DIVISION OF FIRE CODE ENFORCEMENT
ADMINISTRATIVE INTERPRETATION 7-01AM

CODE REFERENCE: Executive Regulations Number 6-06AM Section 31.

EXAMPLES:

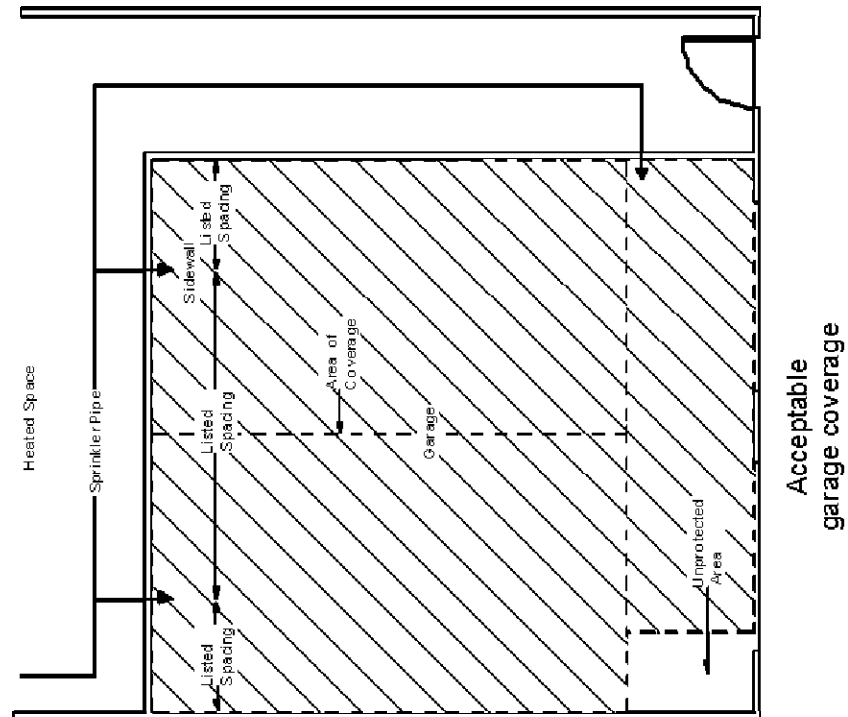
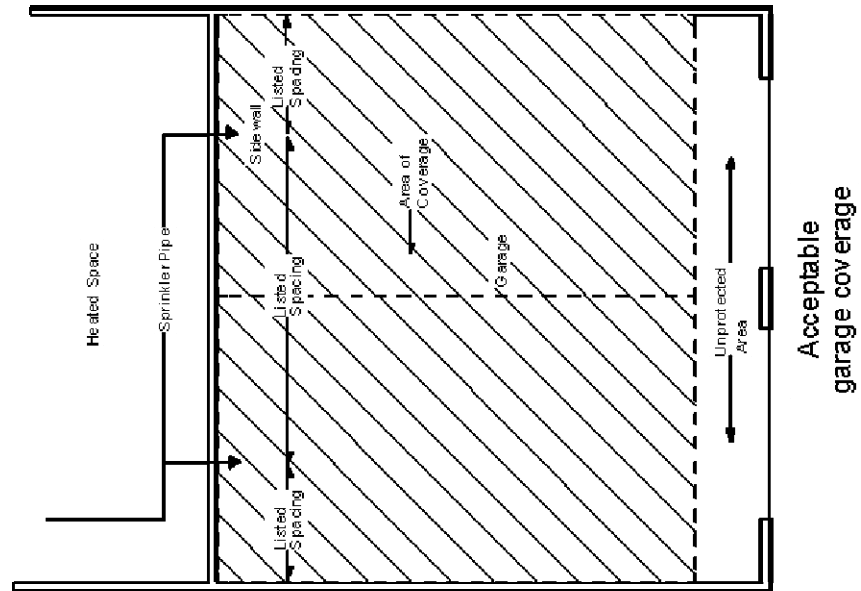
INTERPRETATION: It is not our intention to require complete coverage in the garage. Dry sidewall sprinklers supplied from all walls separating the garage from a heated space in order to cover the largest possible area of the garage shall be considered compliant. The garage does not require a higher density than the residence. See attached.
